Continuous Power Proposals May 22-23, 2001

Karl Nakamura, Cisco Systems

Continuous Power Specification, Power Provided from PSE, measured at the PSE

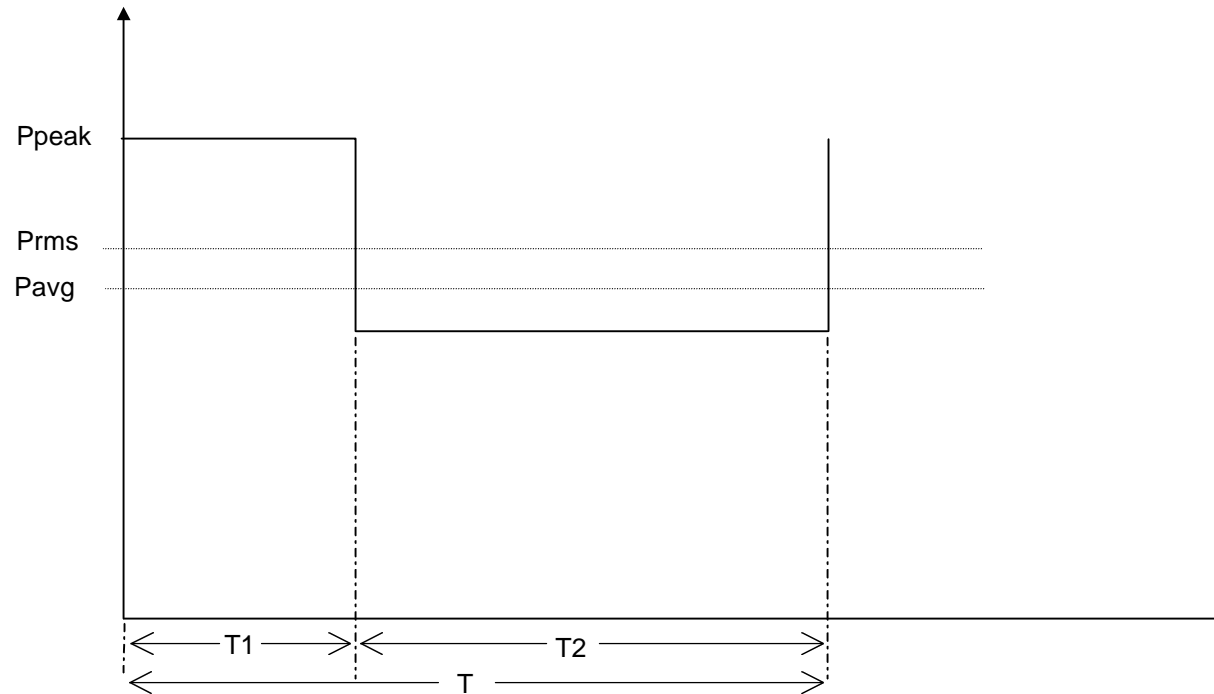
- **The chart on slide 2 is an ENVELOPE, not a required waveform. (5/22, 10:30am)**
- **On the envelope, should there be a slew rate requirement on the rise and fall? (5/22 noon)**
